Rezoning Transportation Analysis

Petition Number: 2019-156

General Location Identifier: 08114708, 08114709

Date	Description
12-19-2019	First Review

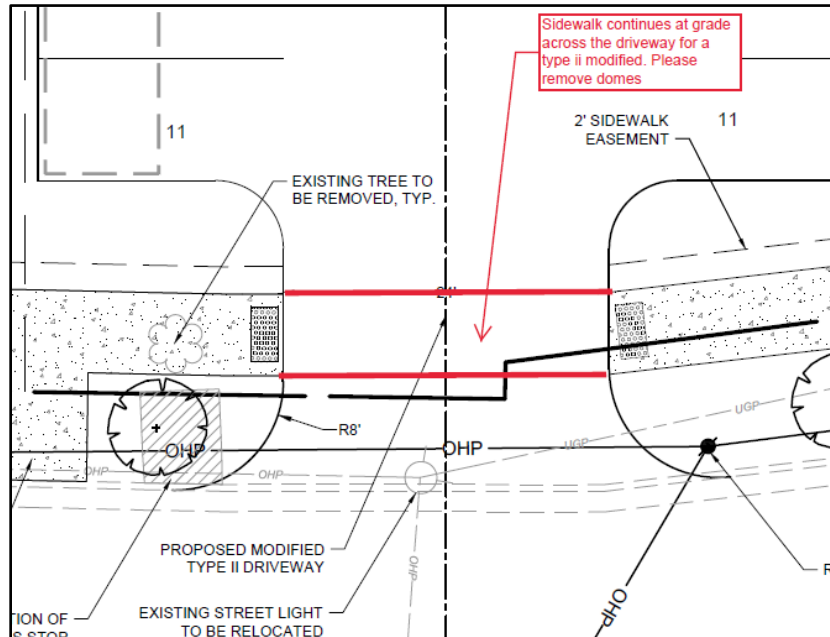
2. **Traffic Study** A Traffic Impact Study is not necessary for the complete review of this petition.
3. The petitioner should revise the site plan and conditional note(s) to commit to construct two directional ramps at the intersection of Parkwood Avenue and Pegram Street, per the *Parkwood (N. Davidson - The Plaza) Improvements* construction plans. Please refer to these plans within the rezoning site plan and conditional note(s). The Parkwood (N. Davidson – The Plaza) plans are available upon request.

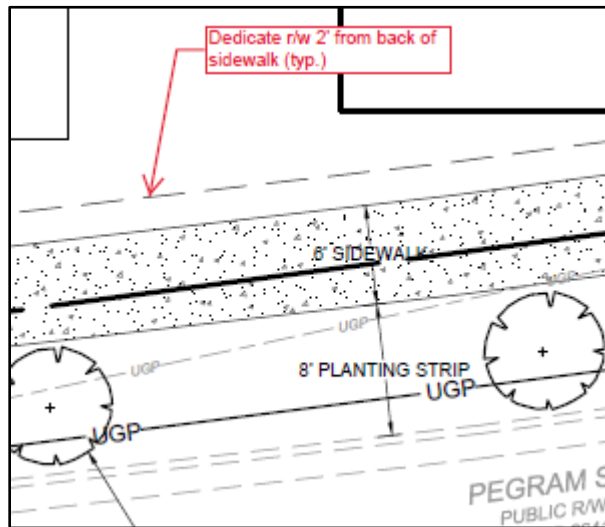
- The petitioner should revise the site plan and conditional note(s) to remove the truncated domes and to continue the sidewalk at-grade across the driveway.

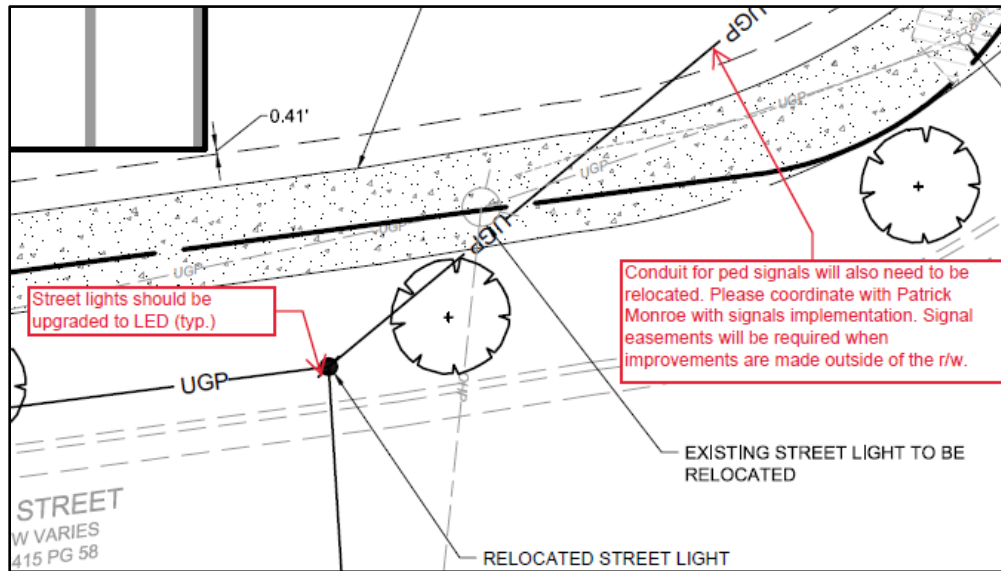
7. The petitioner should revise the site plan and conditional note(s) to clearly define the on-site ordinance required bicycle parking.
8. ~~Resolved~~ Sample format for comment that is resolved
